Independent Environmental Audit

Construction of the new Wentworth Point High School (SSD-11802230)

25 August 2023
Audit No. 2
FINAL REPORT

Photo 5: A tree adjacent to the site was located behind a traffic calming island and not in the impact zone of heavy vehicles.

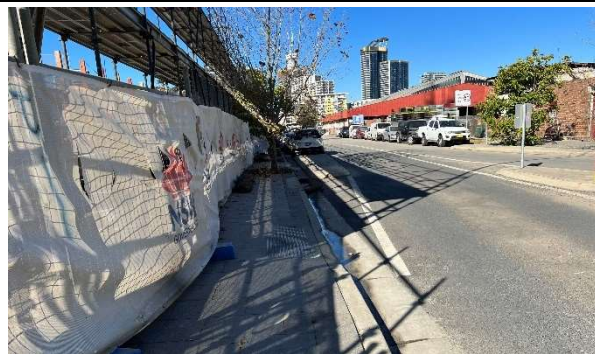
The site boundary fence was encroaching on the street foot path. A Temporary Road and Footpath occupancy permit was obtained from Parramatta City Council.
